STAFF REPORT: 4/14/2021 MEETING

APPLICATION NUMBER: #21-7157

ADDRESS: 1466 SEMINOLE

SCOPE: REPLACE EXISTING FRONT ENTRANCE WALKWAY, NEW STEPS, LANDSCAPING

6- Front Walk Existing, detail

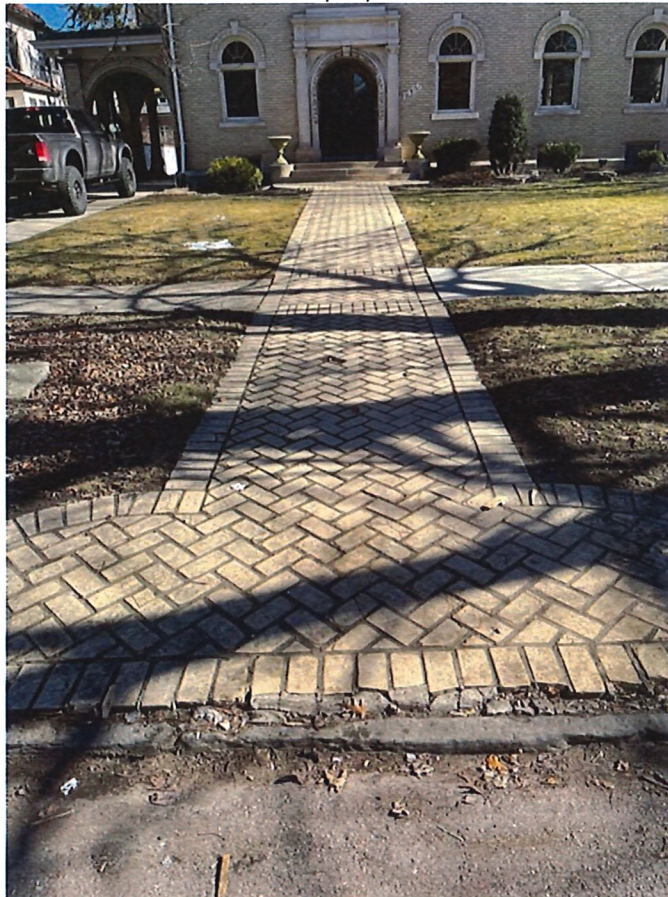
- *Would the owner be open to a combination of having the original brick as an edge to the proposed walkway?*

No. Photos# 6-8 show the wear and tear of the brick pavers long term. The pavers provide a hazardous slick surface when wet that the applicant desires to remedy. This walkway currently in place is not original to the home. As installed by prior homeowner, a violation was issued in 2000 with no Commission review.

SHEET DESCRIPTION:
ARCHITECTURAL SITE PLAN-
PROPOSED IMPROVEMENTS

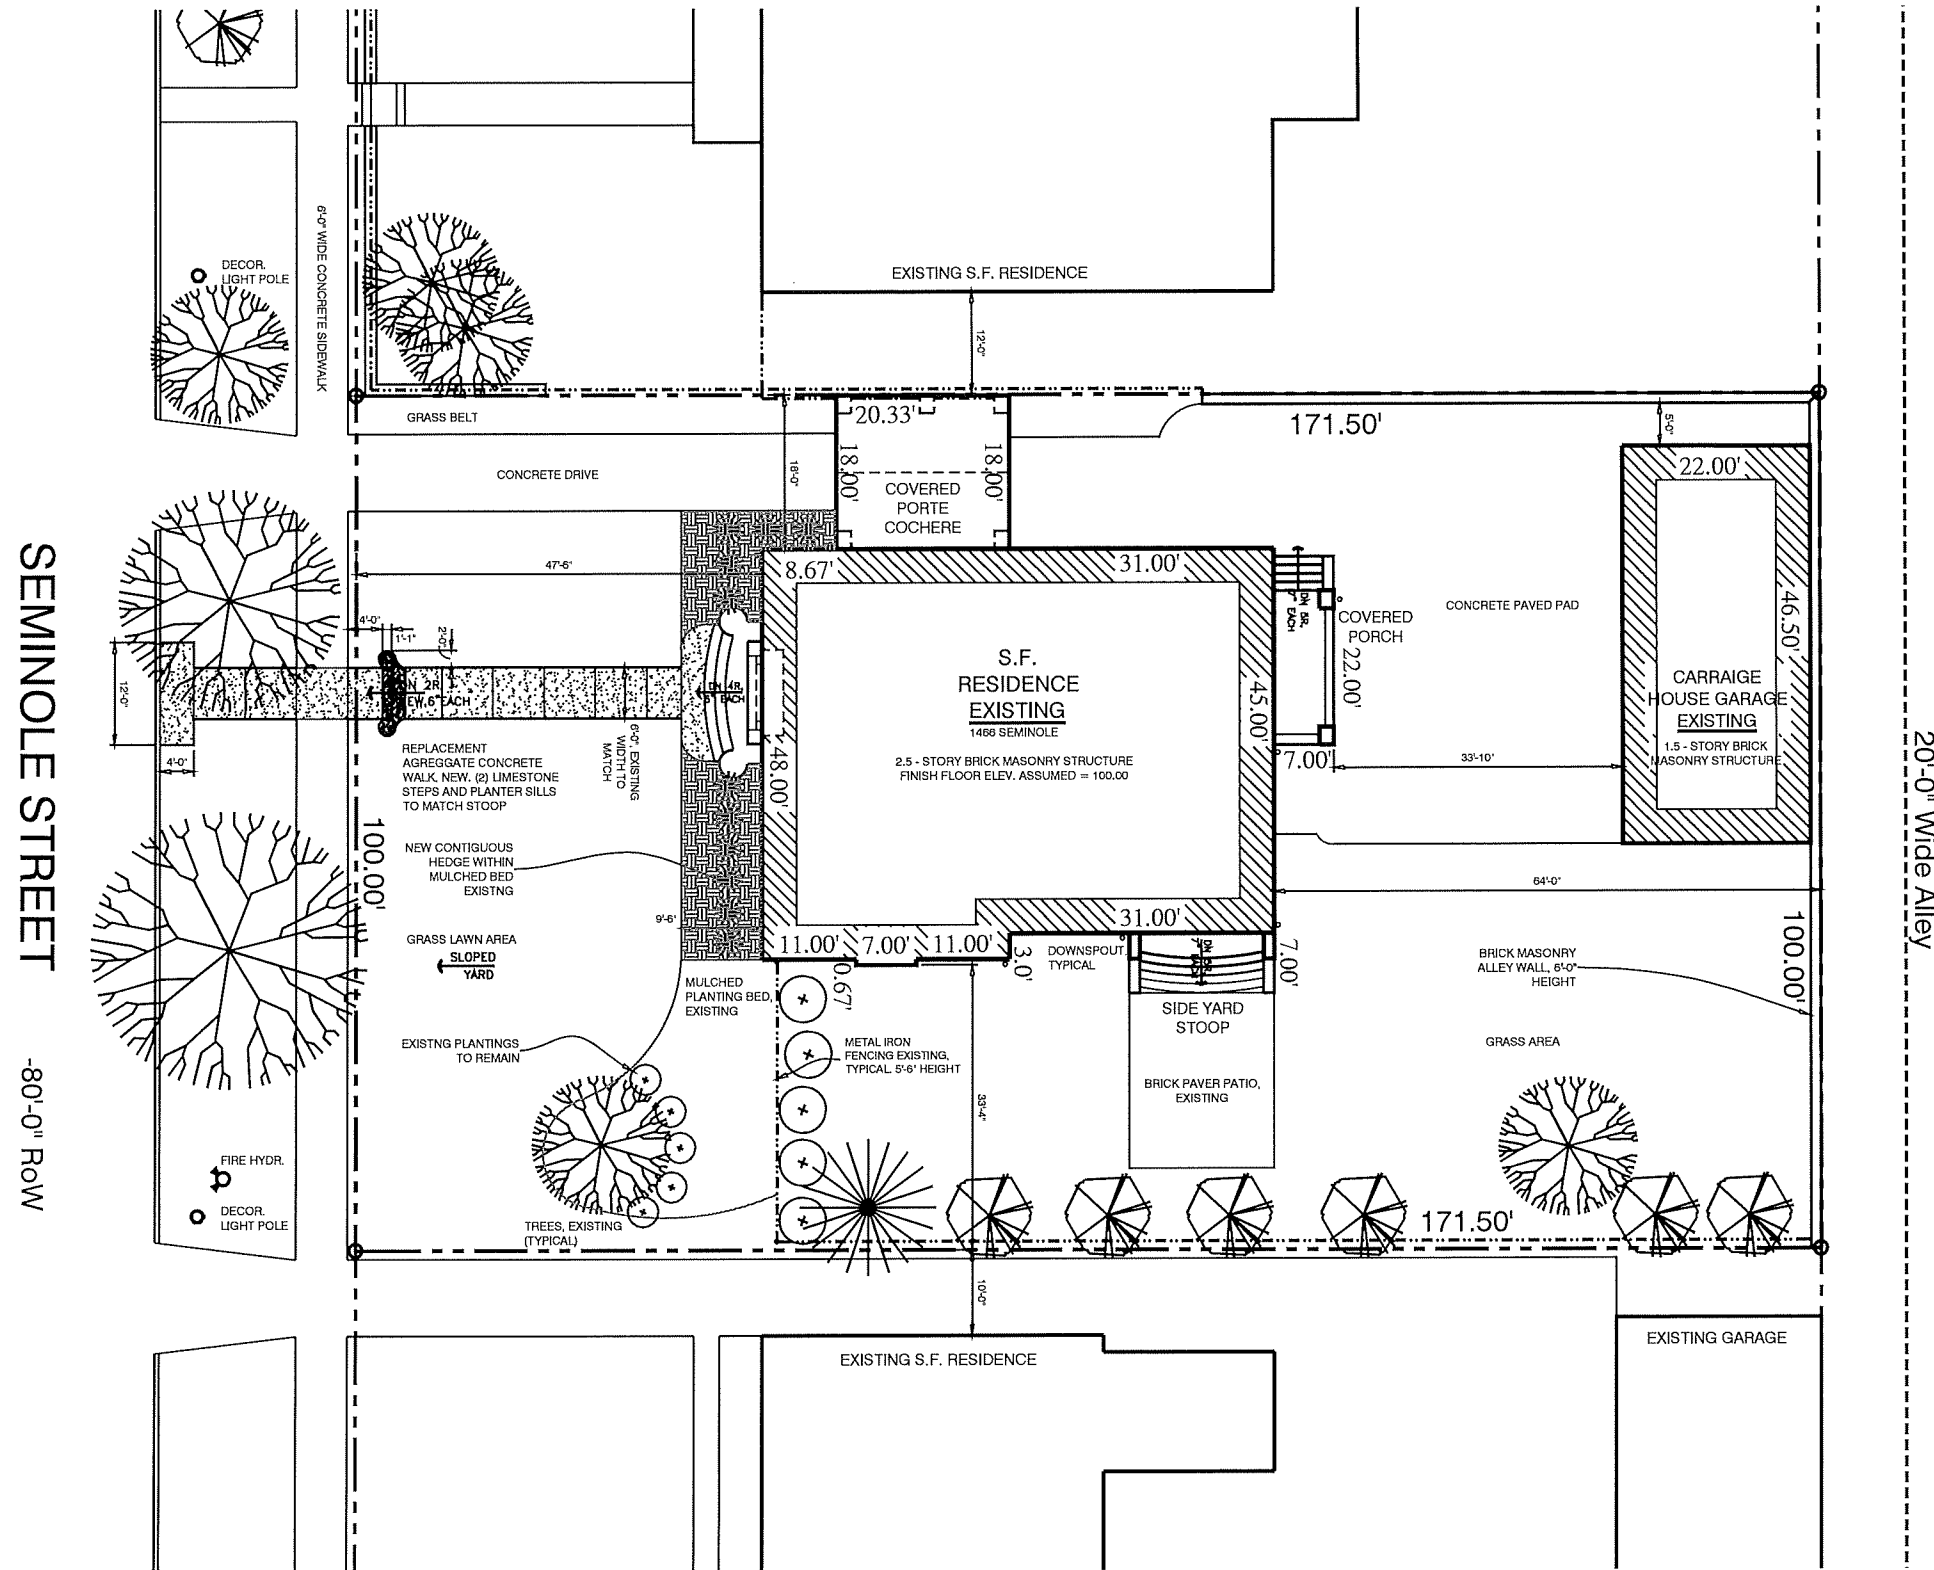
- *The proposed site plan (A-1) shows hatching on the public sidewalk. Are you proposing to change/alter the existing public walkway? If so, please describe what is being changed.*

Yes. Drawing A-01, with Photos #1 and 8 show the front approach current (brick pavers) intersecting the public sidewalk. This 6'-0" x 6'-0" portion will be removed and replaced with **a new concrete slab** to match elevation/material of that adjacent North/South, compliant with City specifications.

ENLARGED AREA OF WORK

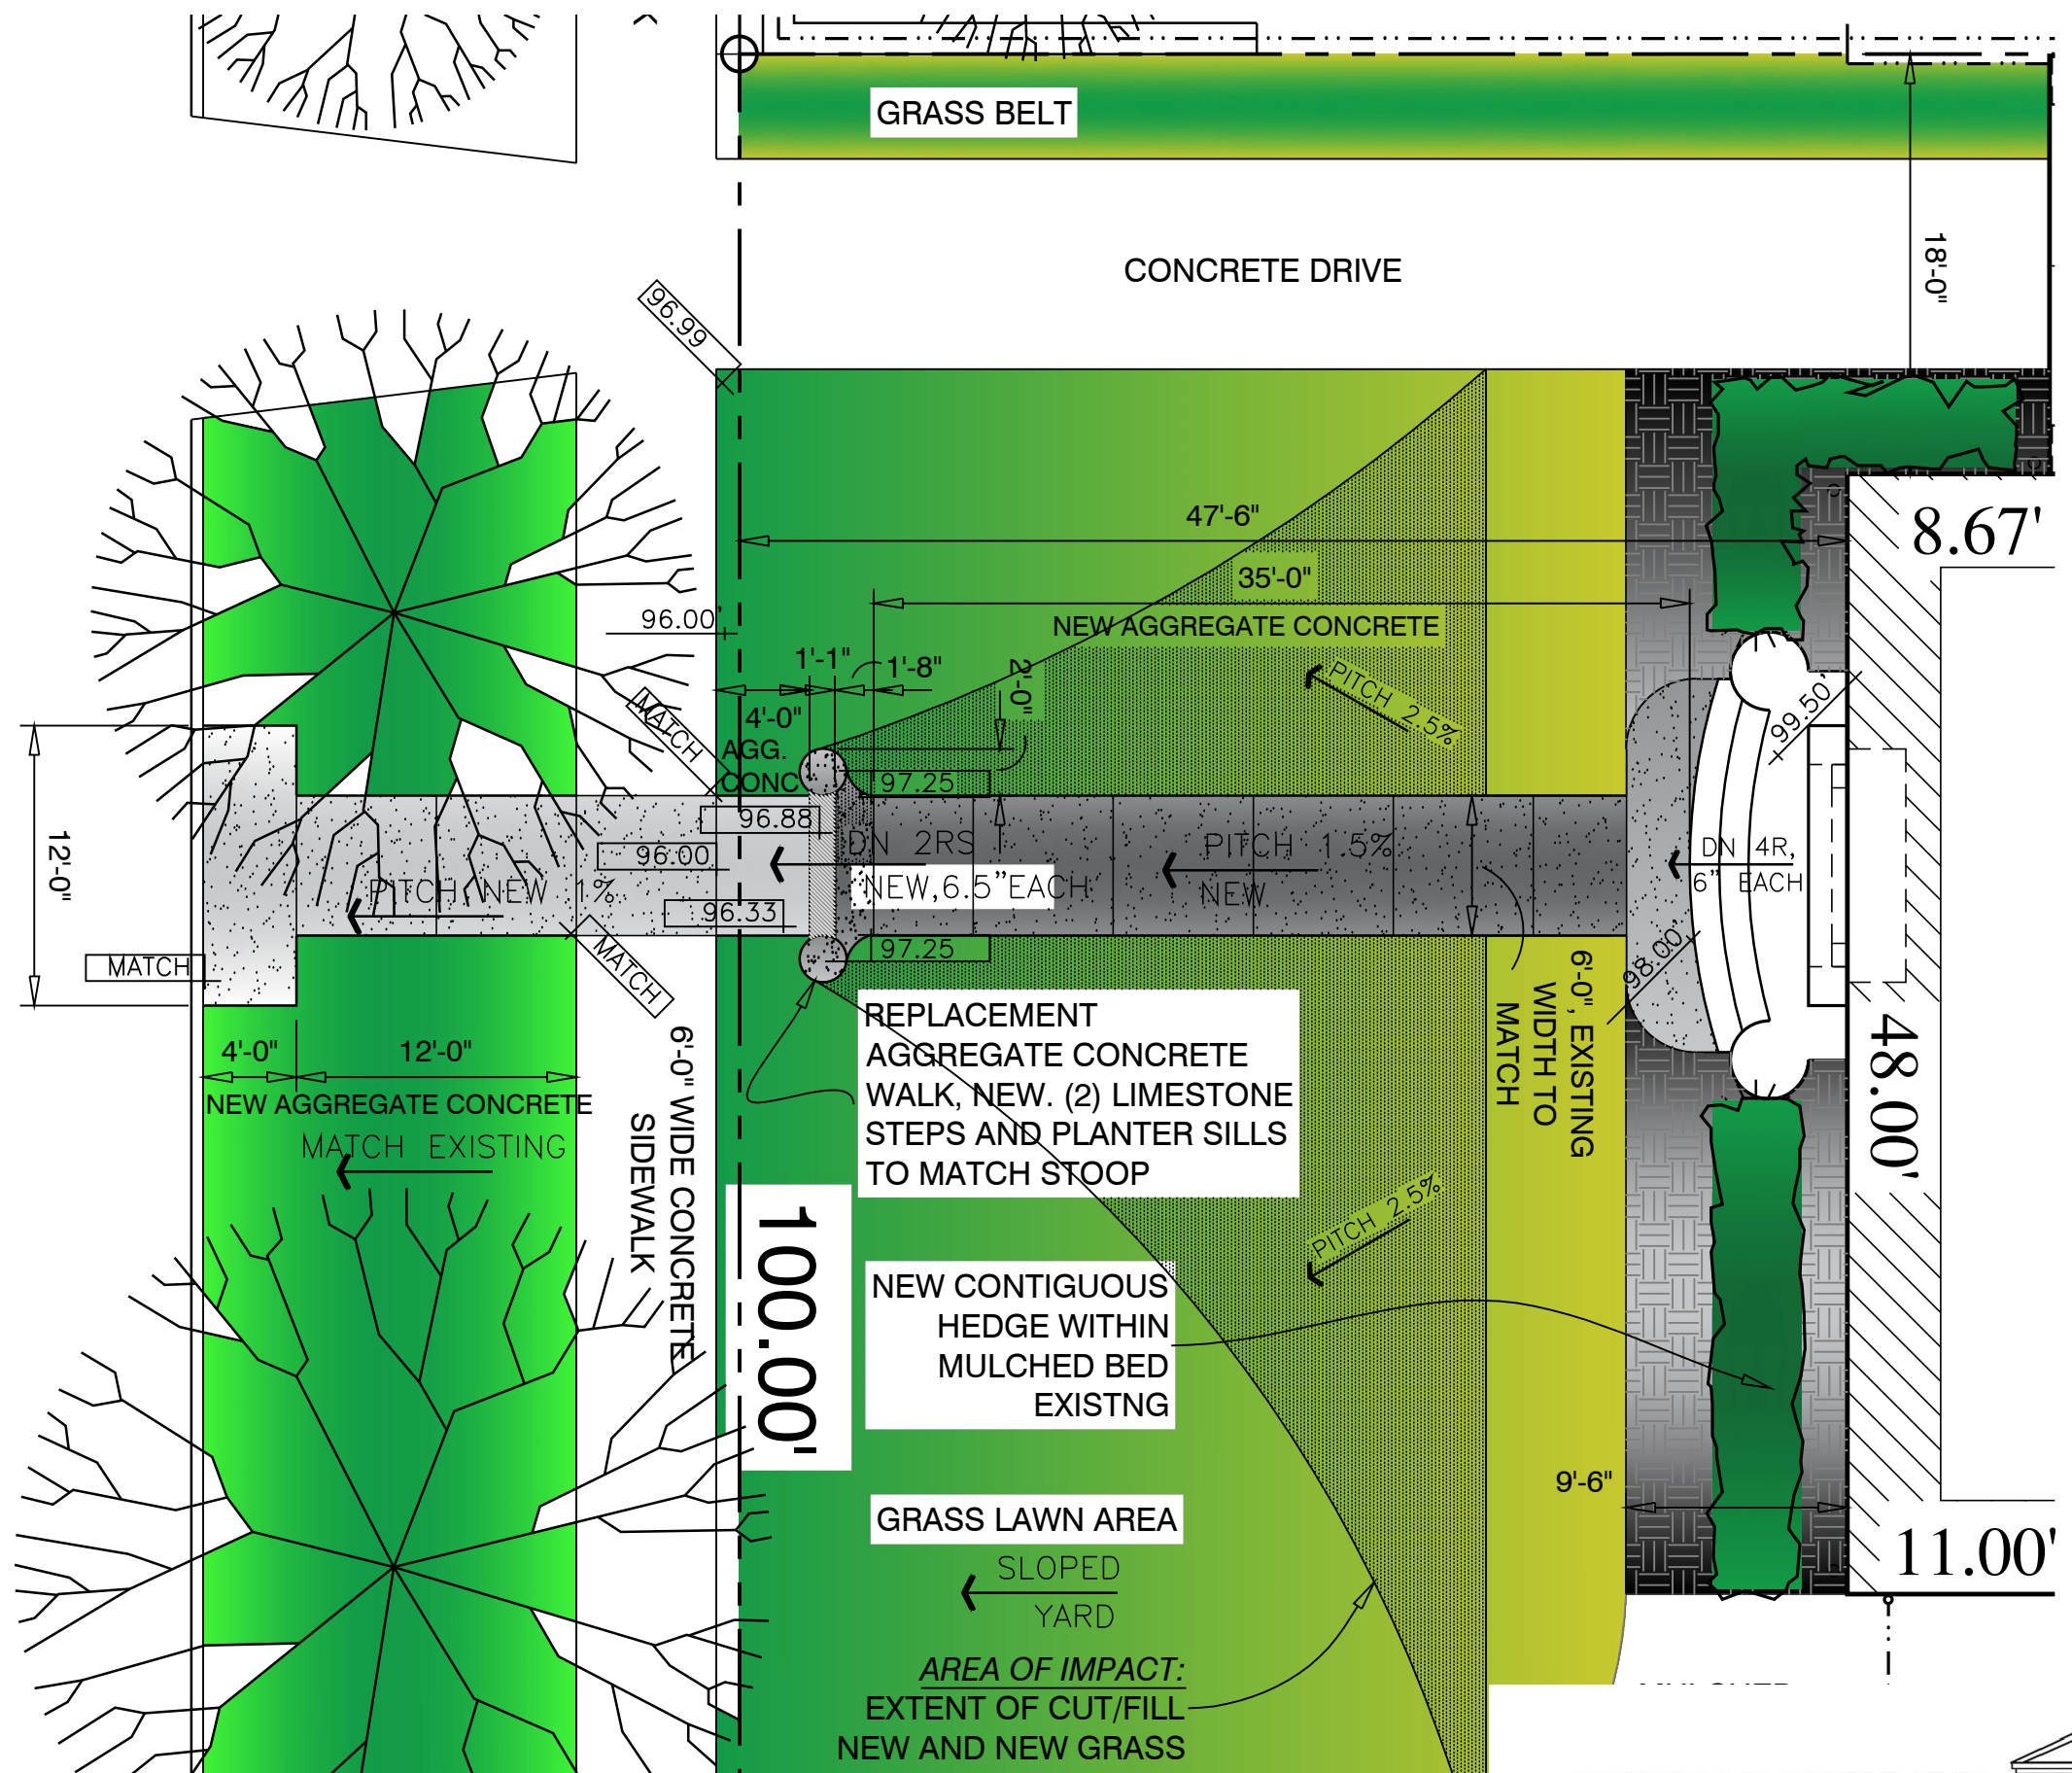
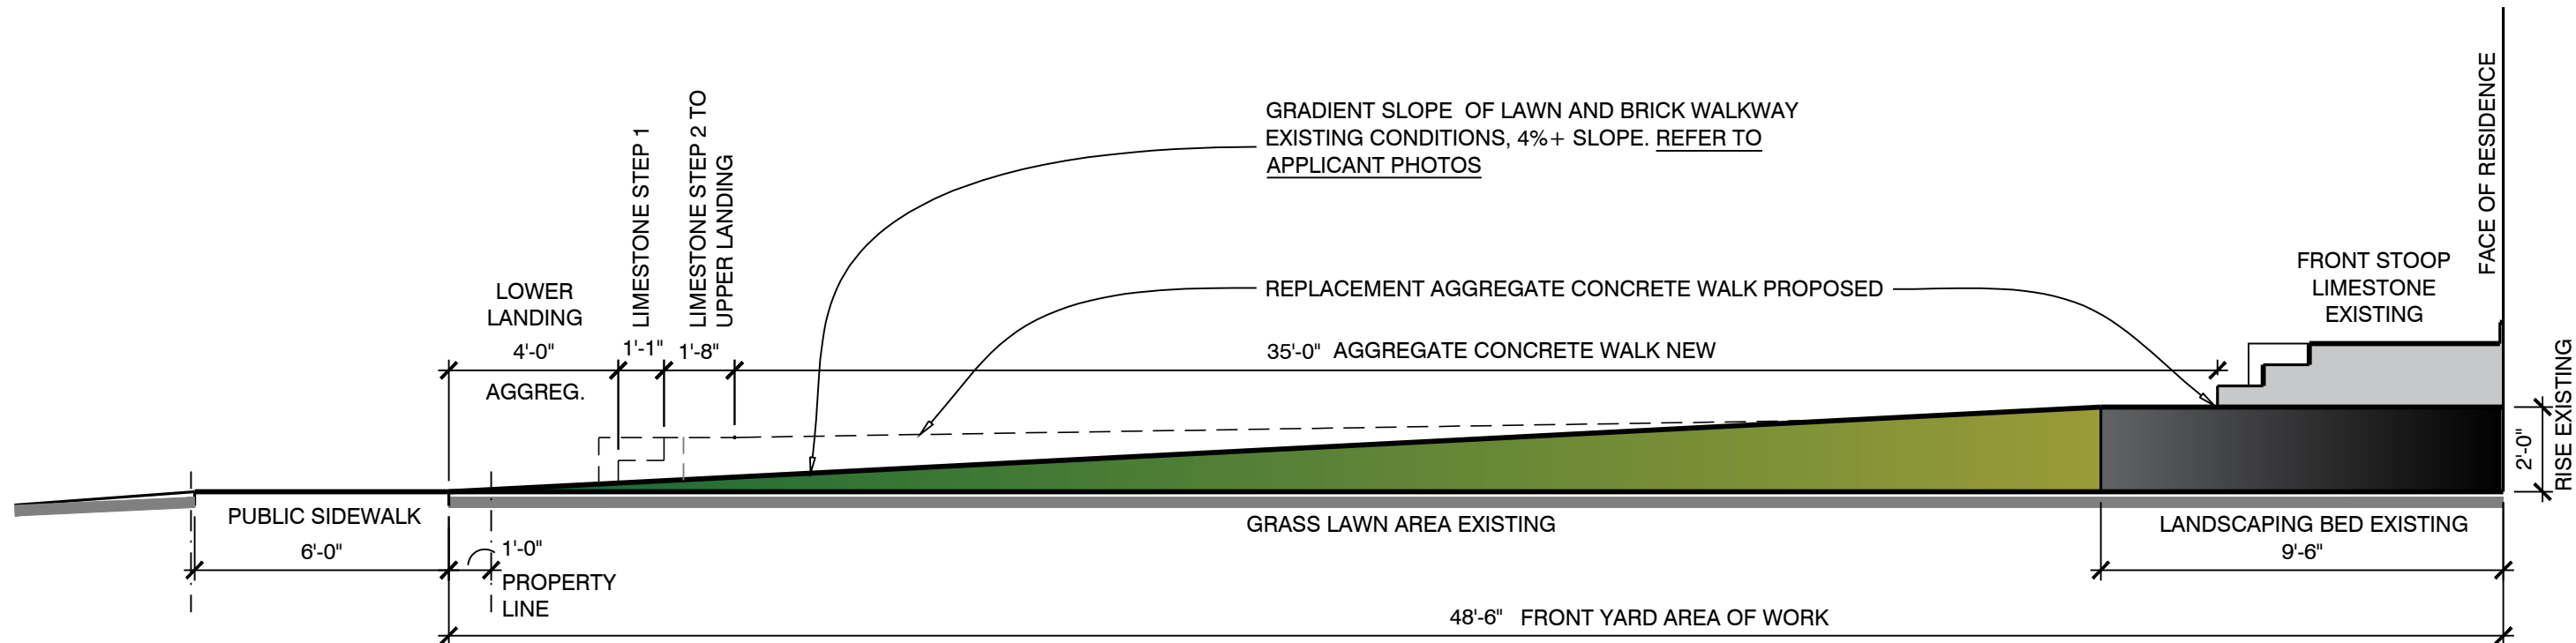
- *Please provide spot elevations and pitch (% slope) of the walkway from the existing steps to the proposed steps, bottom of proposed steps to the curb. Top and bottom of slopes is all that we need to show how grade is changing from existing to new grades.*

Enlarged Area Work plan is updated to provide for design intent clarity. Applicant/owner verified civil grades necessary for existing yard slope and proposed new work. *Existing is 24" drop from the face of the residence to the City public walkway.*

Please see the Enlarged Area of Work Plan revised.

ENLARGED FRONT WALK WEST ELEVATION AND SITE SECTION

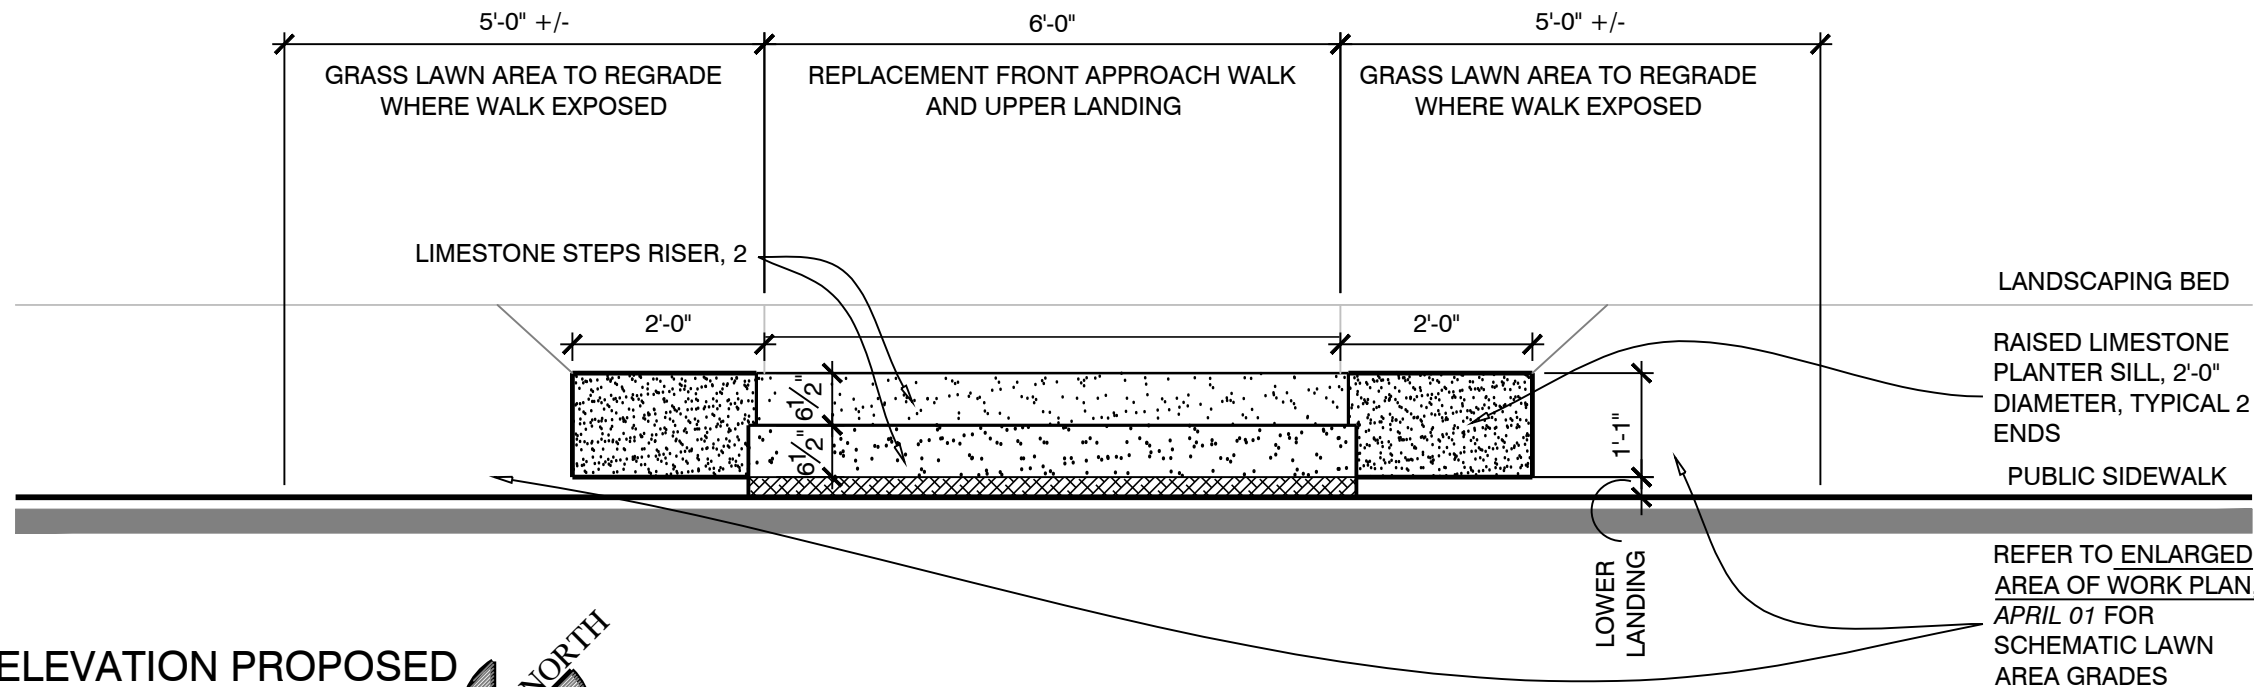
- Upon receipt of the application, Staff requested the following details regarding the applicant's proposed scope of work.
 - Show an elevation with details, dimensions and slopes for the proposed walkway and new staircase. The updated plan shows slope lines, and plan dimensions of the steps and "limestone sills". Staff received confirmation that the height of these "limestone sills" will be flush with the ground plane. The updated plans show that the steps consist of 2 risers and 3 steps (treads).

- *Do you have a detail on the proposed step(s) with dimensions and an elevation? We would like to better understand what is the feature, its materials, dimensions both in plan and elevation(s).*

I do not have a detail prepared at this time for the HDC package. I would be happy to accommodate following approval of the Commission, with the Staff report suggestion of "Permit set be reviewed prior to final approval" as a condition. Plan dimensions have been provided upon Sheet A-1, better viewed upon the color **Enlarged Area of Work plan**. *Each step will be 6" to 7" high maximum. The material of the upper step, planter sills and the bottom step are proposed limestone, to match the front stoop existing.* (Photos #5 and 6 in material and massing). **Risers will be linear and not curved.** The aggregate walk will be between the upper limestone tread/landing and existing steps, **and** lower proposed limestone step to the public sidewalk. The aggregate walk is proposed again within the right-of-way, from the public sidewalk to the street curb. Please reference the enlarged plan notes and dimensions updated.
